Report: TAB REPORT
Function: Test, Adjust, & Balance
Date: 03/25/2025
Completed By: National TAB

03-24-25 CHIPOTLE #5326 GREENFIELD, WI

Issue List

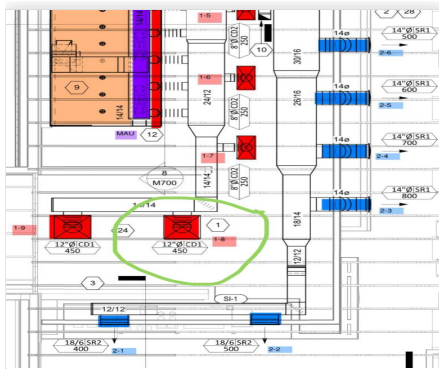
Issue Name : 02. RTU-2: Turbo Nozzle Diffusers Not Installed
Description : Diffusers 2-3 thru 2-7 are not installed. Unable to balance system as installed dampers are not accessible and cannot be secured if adjusted. Turbo nozzles to be installed with face accessible dampers.
Created By : National TAB **Assigned To :** National TAB - Michael McDonnell
Status : Open
Priority : High **Asset Tag :**
Originated Date : 03/25/2025 - Michael McDonnell - National TAB
